EGG-SSDC-5288

HUMAN FACTORS ENGINEERING EVALUATION OF  
THE ADVANCED TEST REACTOR CONTROL ROOM

M. P. Boone  
W. W. Banks

Figure 13. Cathode-Ray tube display located behind reactor console.

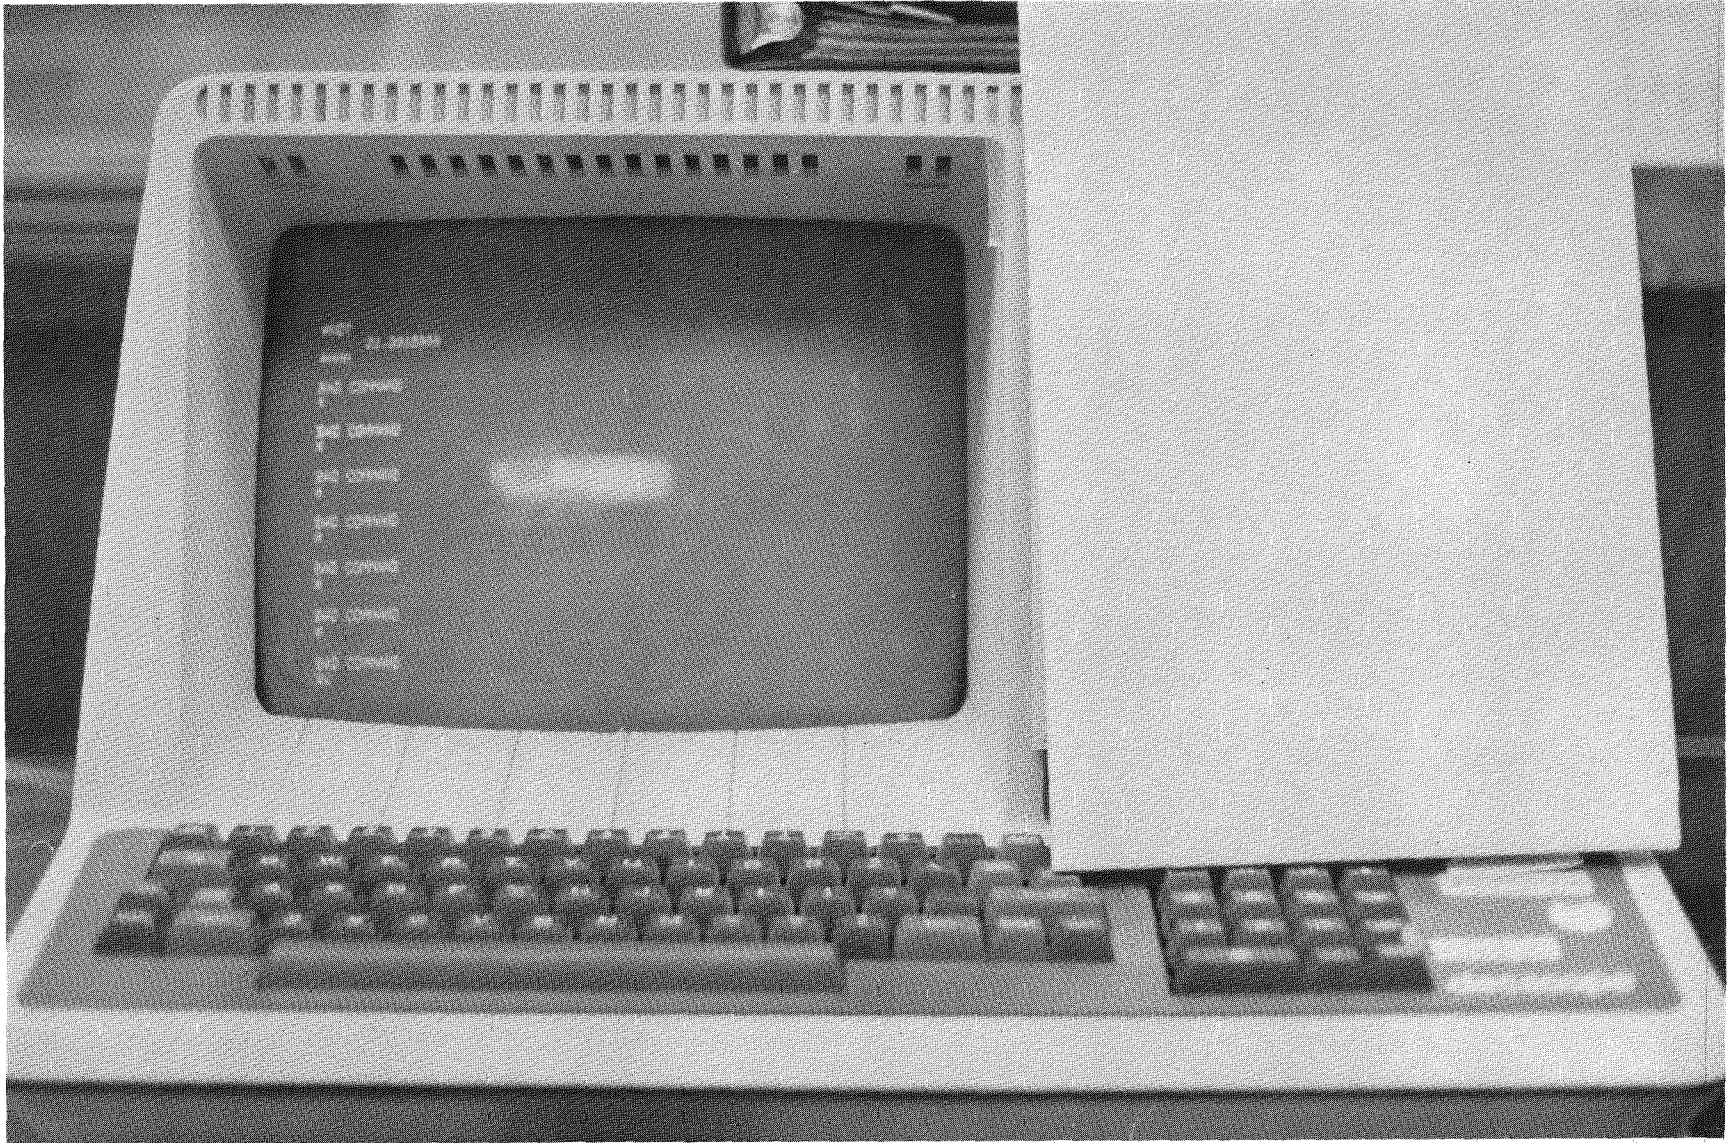
Location--The cathode-ray tube (CRT) display located on a desk in back of the reactor console (see Figure 13) can be used to access any of the programs in the ATR computer. The information most often requested by operators concerns temperatures, pressures, and flows of the loops. The tables of information about each loop are used in conjunction with the console-mounted power split display by operators to more accurately determine what reactor power changes need to be made. A marked increase in the use of the CRT display has been noted when two operators are in the control room. Interviews with the operators revealed that the reason a single operator does not make full use of the display is because it is physically separated from the reactor console. It is, therefore, recommended that a display which gives the same information as shown on the CRT display be integrated into the reactor console due to the importance of the loop information, particularly during start-up. The CRT on the reactor console could be used as a dual-function display showing either the power split or any other desired information. An analysis of the amount of time operators use the dedicated power split display could determine the advisability of modifying the dedicated displays in such a way that it becomes a multifunction CRT. If such a modification is not feasible, two displays should be considered.

Figure 14. Procedure panel. (Arrow points to "MOR automatic" light.)

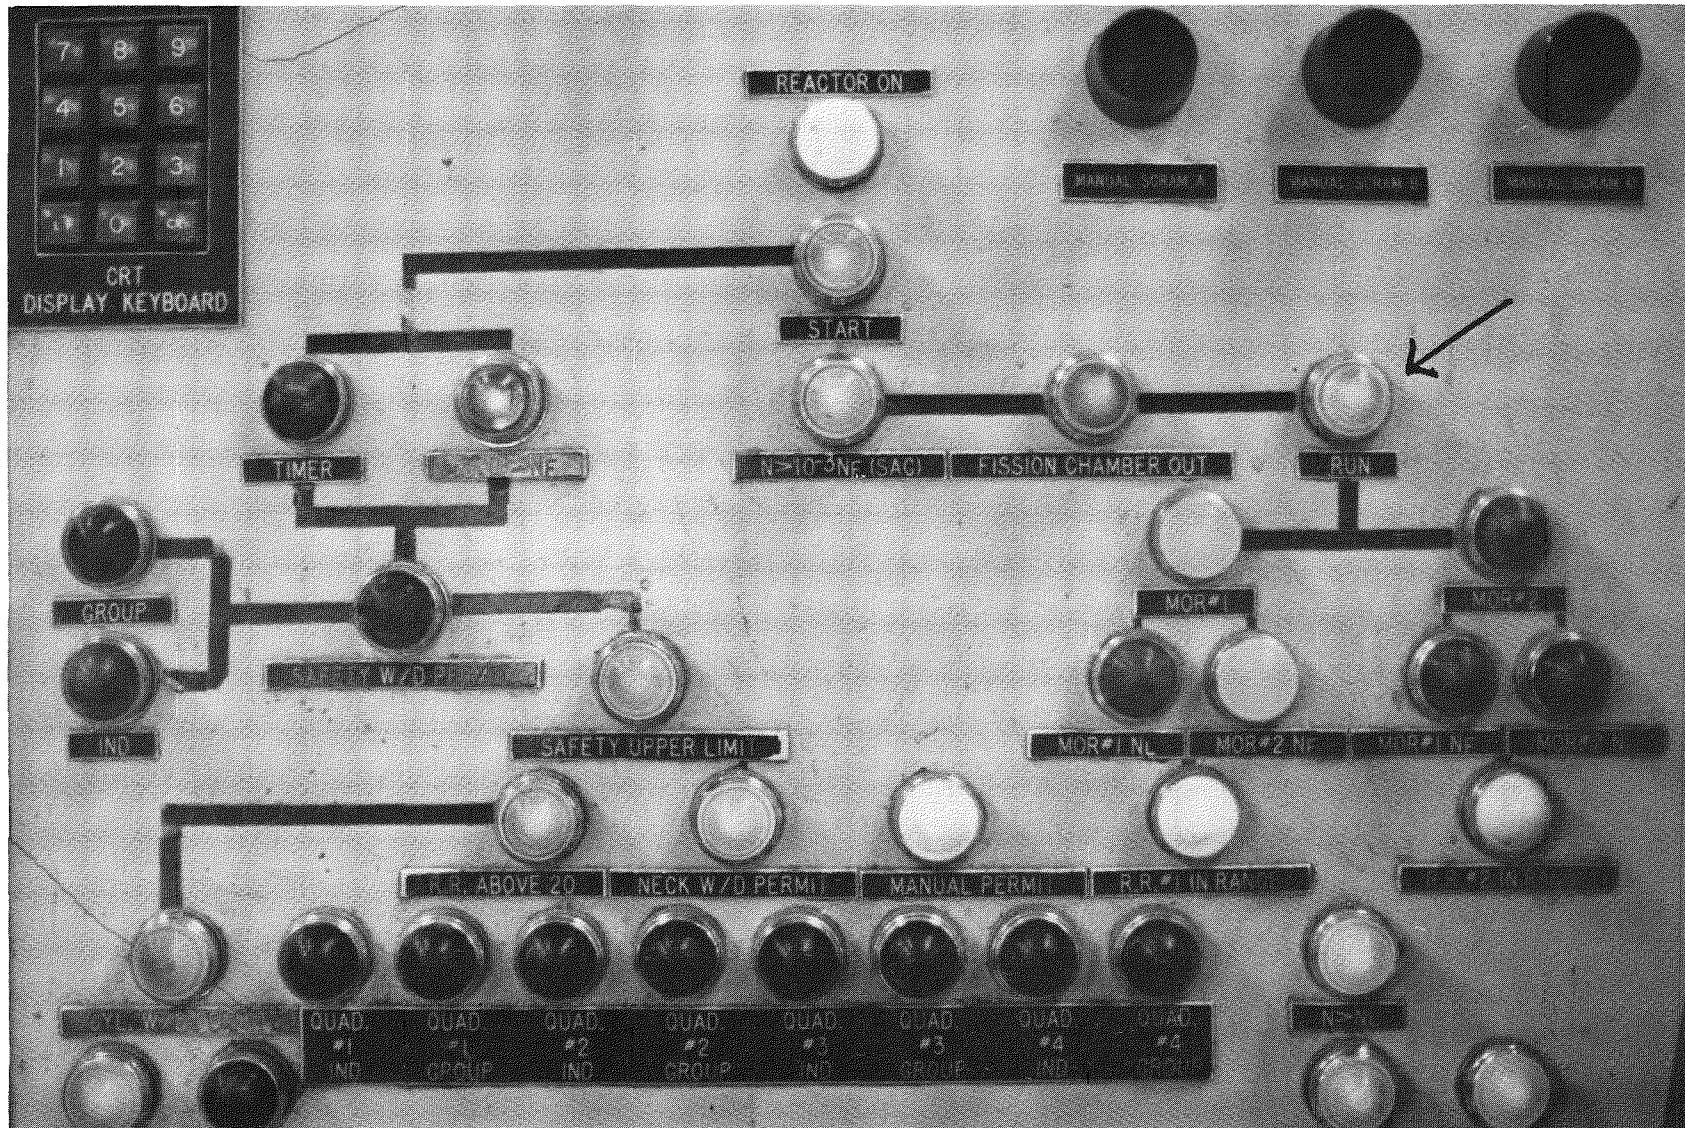
When operating under the automatic mode using the motor-operated rheostat, a number of possible conditions can cause the MOR to enter a manual mode without adequate warning to the operator. The first signal presented to the operator is a change in state of the GREEN "Auto" MOR light: the light will go out. Since this light is located near the seated operator's left knee (see Figure 14, Arrow), there is a high probability the condition will go undetected until the operator perceives "Drift" in the regulating rod script-chart recorder.

To enhance the operator's performance, it is recommended that this light be resituated above the MOR reg rod manual/auto hand control since (a) it is functionally related to this control, and (b) it would be easier and faster for the operator to detect a mode change. It is further recommended that WHITE lights be used to indicate the mode of operation. Since Auto Mode is used more frequently, it might be better to inform the operator only when the system is in manual mode by having a WHITE light come on instead of having a GREEN light go out.

Figure 15. MOR demand meters.

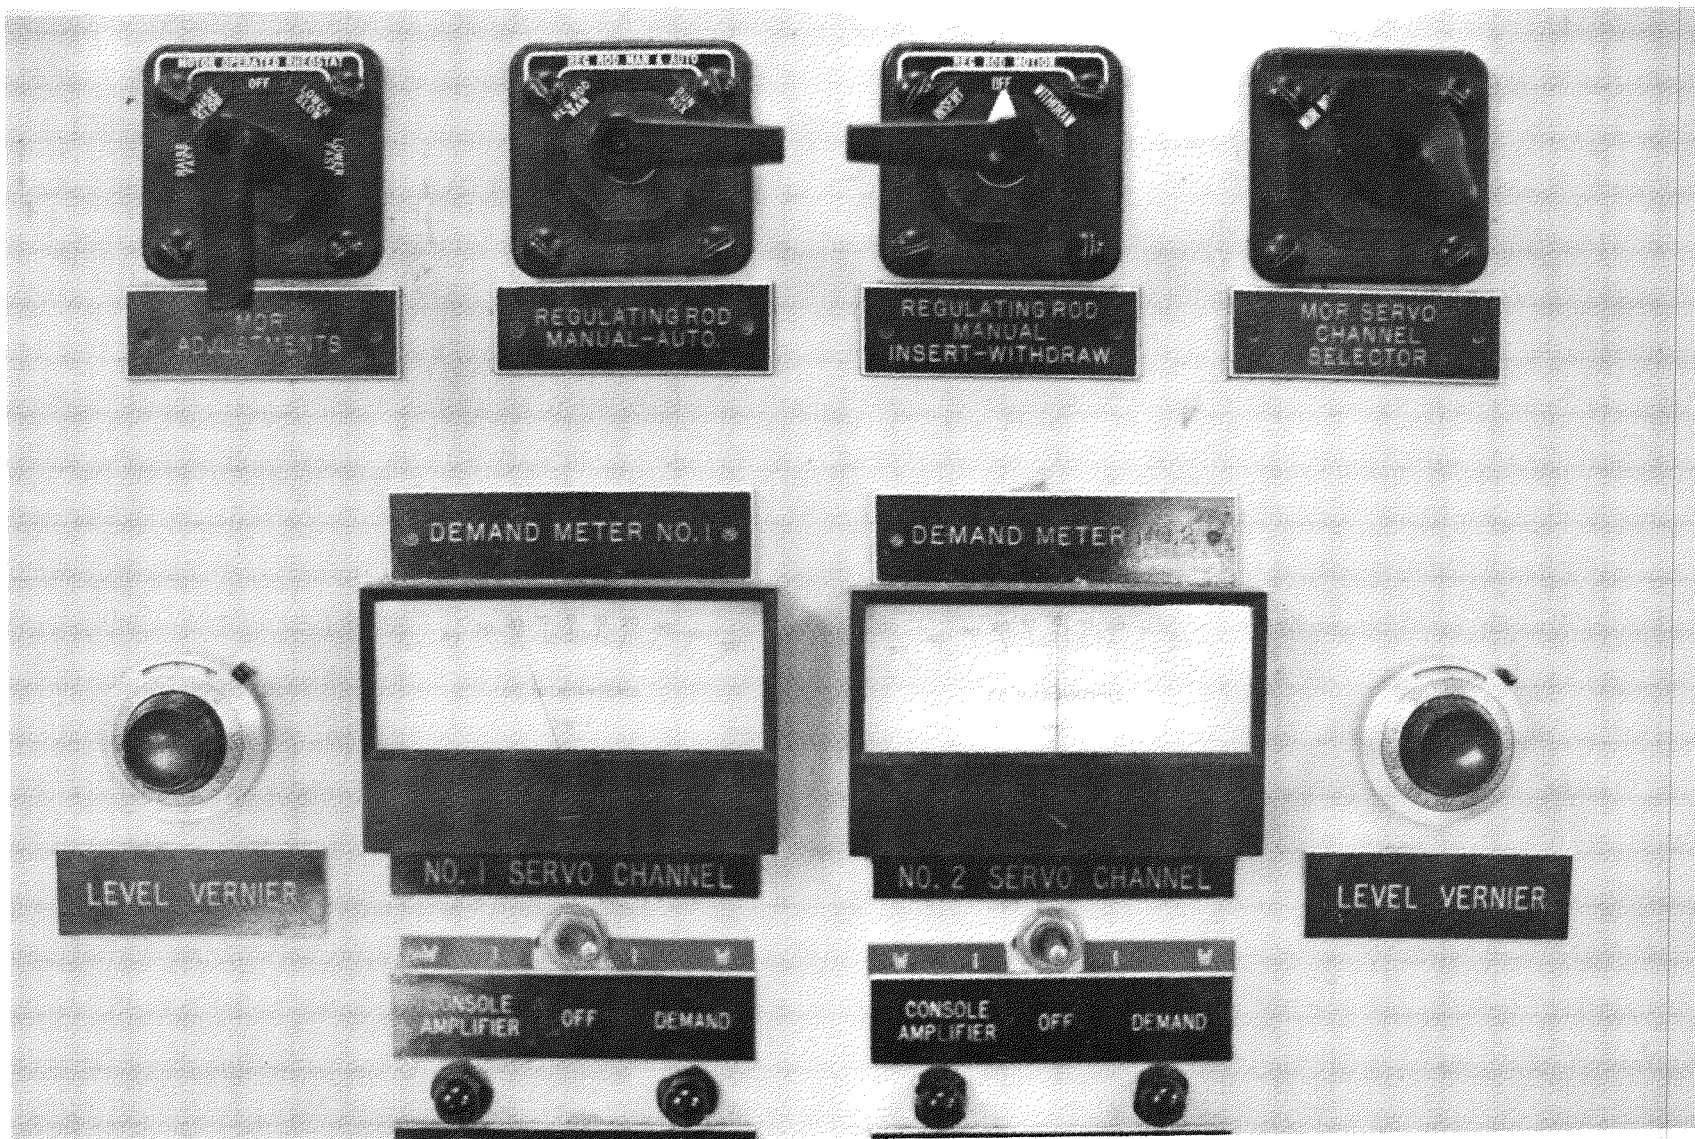
Figure 15 shows the two visual demand meters located on the operator's immediate console. After specific questioning, operators informed us that they only monitor the "Directional Movement of the Pointer." They do not

take numeric readings from the scales. It is recommended that information be displayed to the operator only to the degree of specificity and precision required for the operator to perform his/her job. Additional information serves only as a distraction and is nonfunctional and nonproductive.

Another problem noted with these demand meters concerns the withdraw/insert toggle switch situated directly underneath the meters. When this switch is placed in the left position, the pointer on the scale reads withdraw voltages to the left-of-center scale. When the toggle switch is placed in the right position, voltages are read to the left-of-center scale. Readings should always be consistent. The left-of-center should always refer to the same voltage, either insert or withdraw, but never used as both. This can cause confusion which, in an emergency condition, can significantly degrade operator decision and action quality.

Figure 16 A. Broken pointer on regulating rod manual/auto switch.

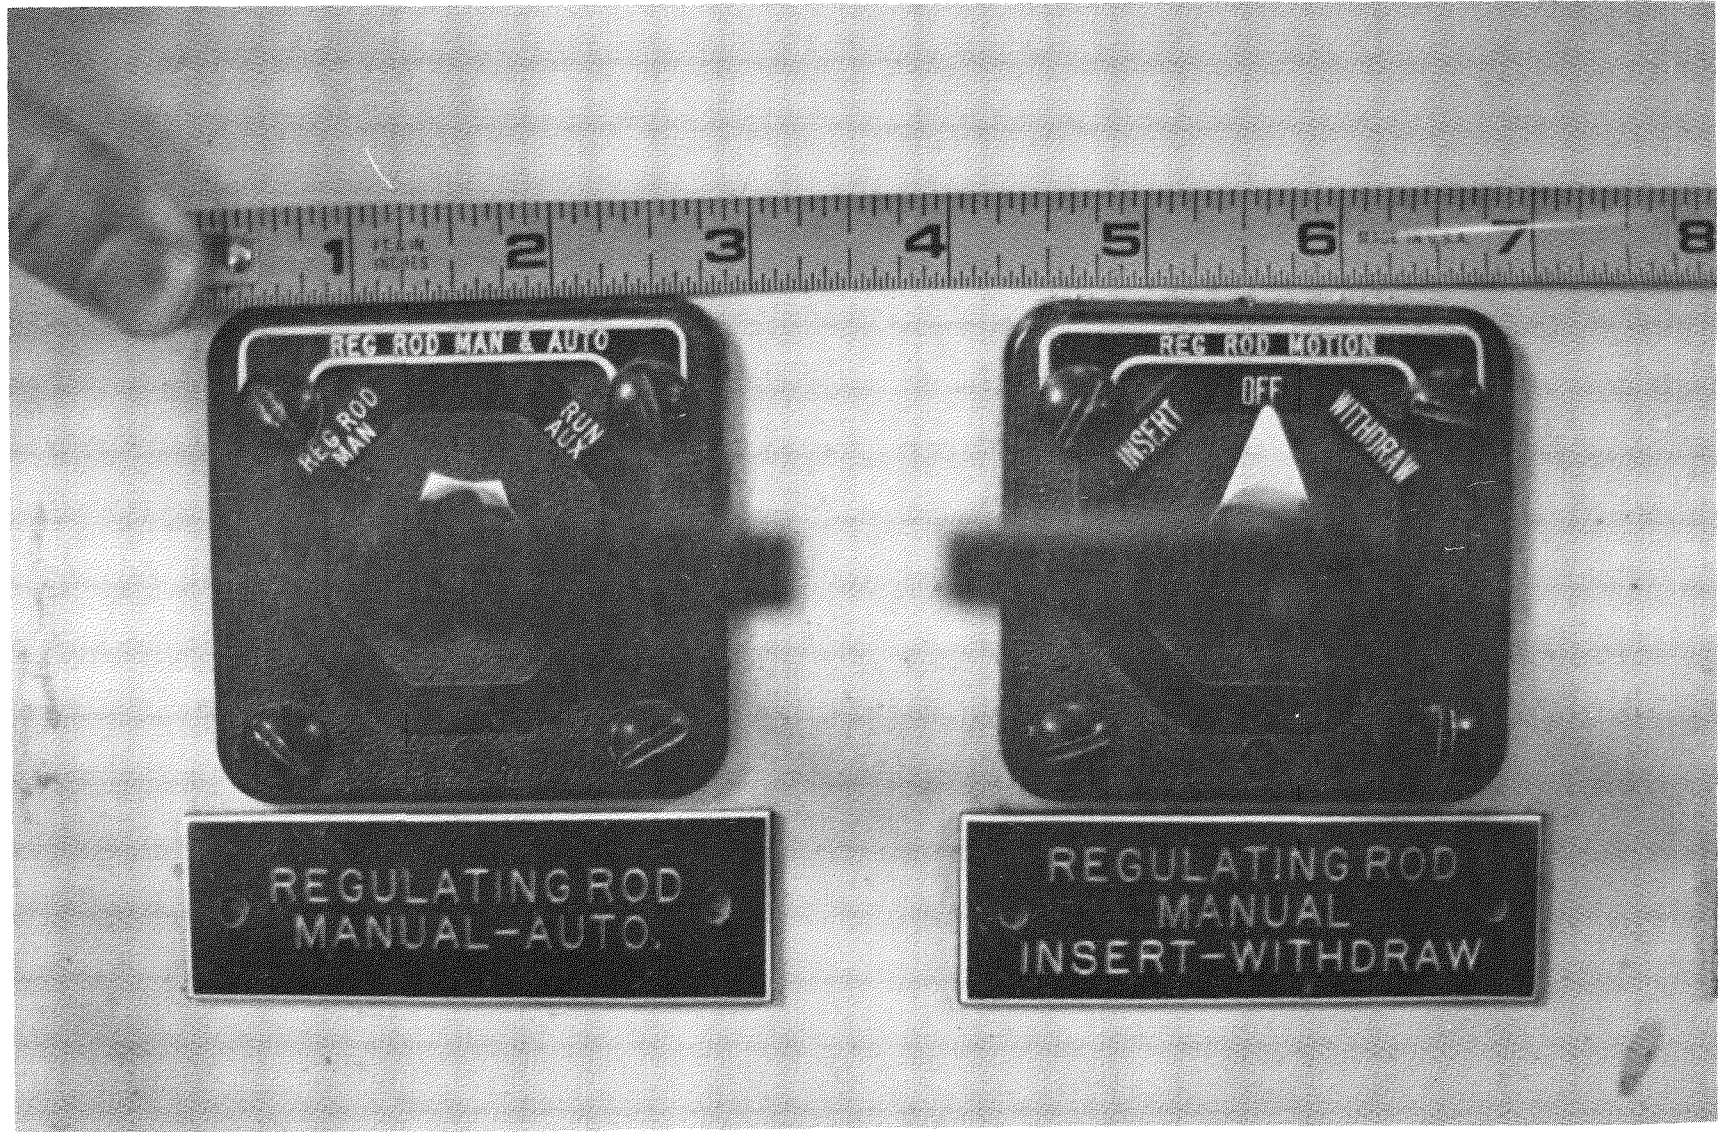
Broken pointers (triangles) were found on the MOR servo channel select, and other hand controls (see Figure 16A). We recommend that all broken pointers be repaired.

Figure 17. Safety rod subsystem. (A common border would reduce the information needed on each label.)

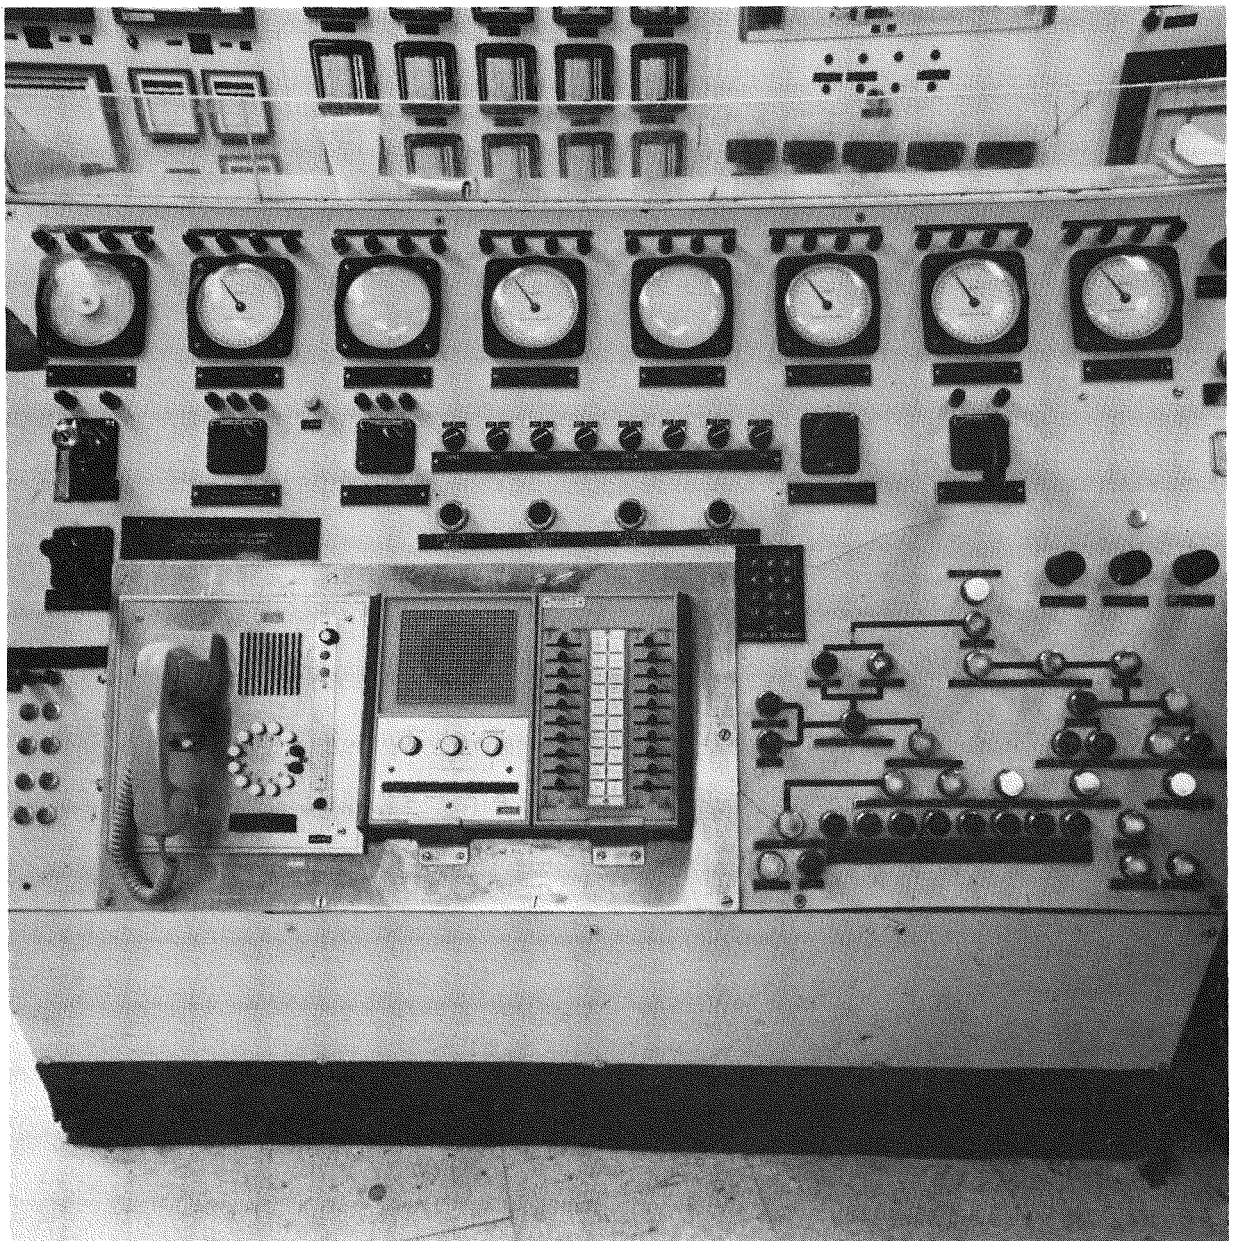
Labeling. There were no distinguishing boundaries between the Safety-Rod Subsystem and other subsystems (Figure 17). It is recommended that these boundaries be incorporated into the system.
